ATTACHMENT TO LICENSE AMENDMENT NO. 164

TO FACILITY COMBINED LICENSE NO. NPF-91

DOCKET NO. 52-025

**Figure 2.2.4-1 (Sheet 3 of 3)**  
**Steam Generator System**

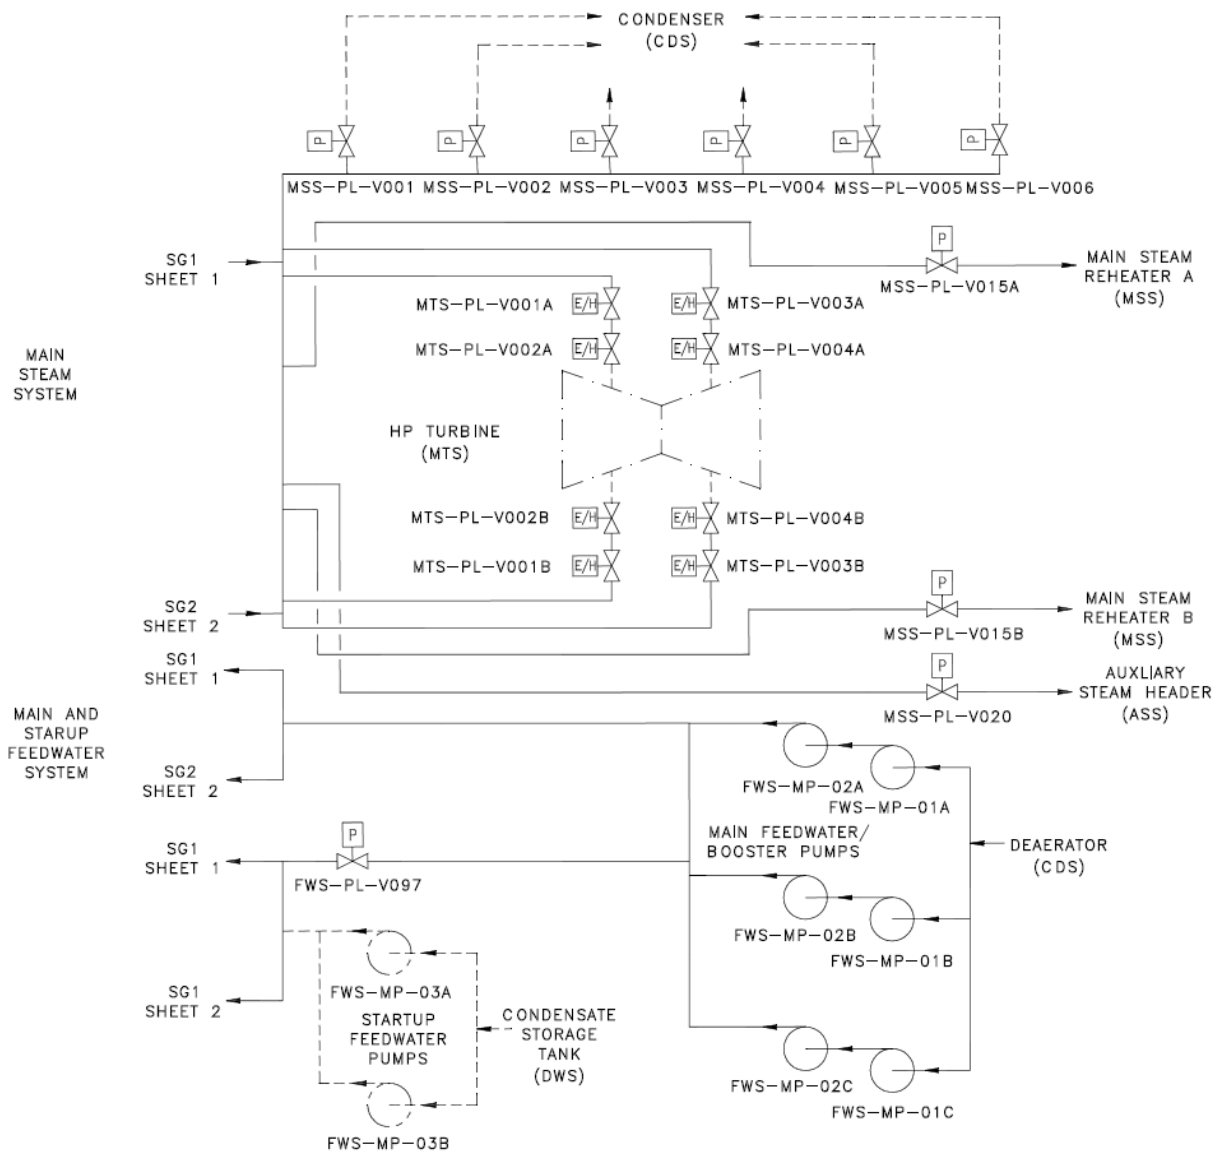
Replace the following pages of the Facility Combined License No. NPF-91 with the attached revised pages. The revised pages are identified by amendment number and contain marginal lines indicating the areas of change.

C-166

C-166
